**BEFORE THE WASHINGTON
UTILITIES AND TRANSPORTATION COMMISSION**

**In the Matter of Puget Sound Energy's
Final Clean Energy Implementation Plan**

DOCKET UE-210795

**COMMISSION STAFF COMMENTS REGARDING
PUGET SOUND ENERGY'S FINAL CLEAN ENERGY IMPLEMENTATION PLAN
SUBMITTED IN COMPLIANCE WITH
CHAPTER 19.405 RCW and WACs 480-100-640 through -665
<AND UNDER CONSOLIDATED DOCKETS UE-191023 AND UE-190698, Order R-601>**

Table 2: 2022-2030 Interim Targets¹⁸

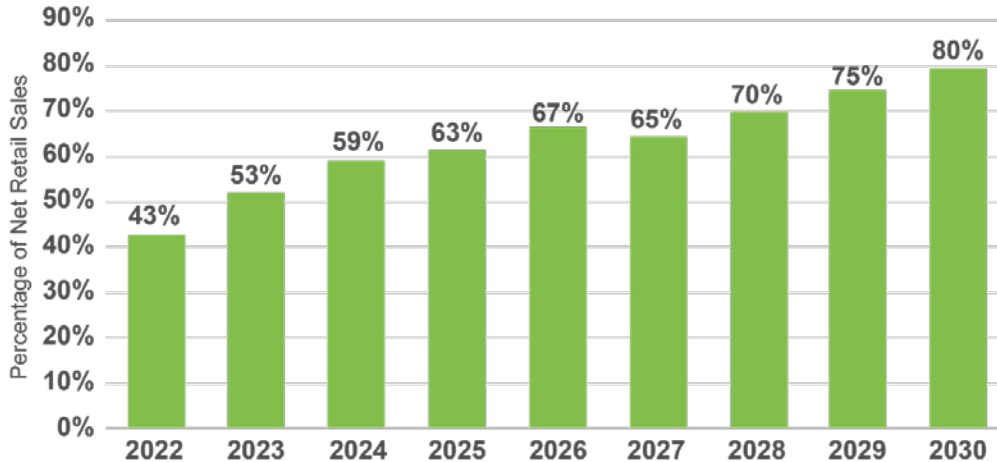
PSE requests approval of an interim target that meets 63 percent of retail sales with renewable or nonemitting energy by 2025, sourced from 800 MW of utility-scale renewables and 80 MW of distributed energy resources. As described above, Staff needs more information concerning the decision-making process that PSE used to decide on the specific glide path shown in Table 2, especially in relation to market reliance.
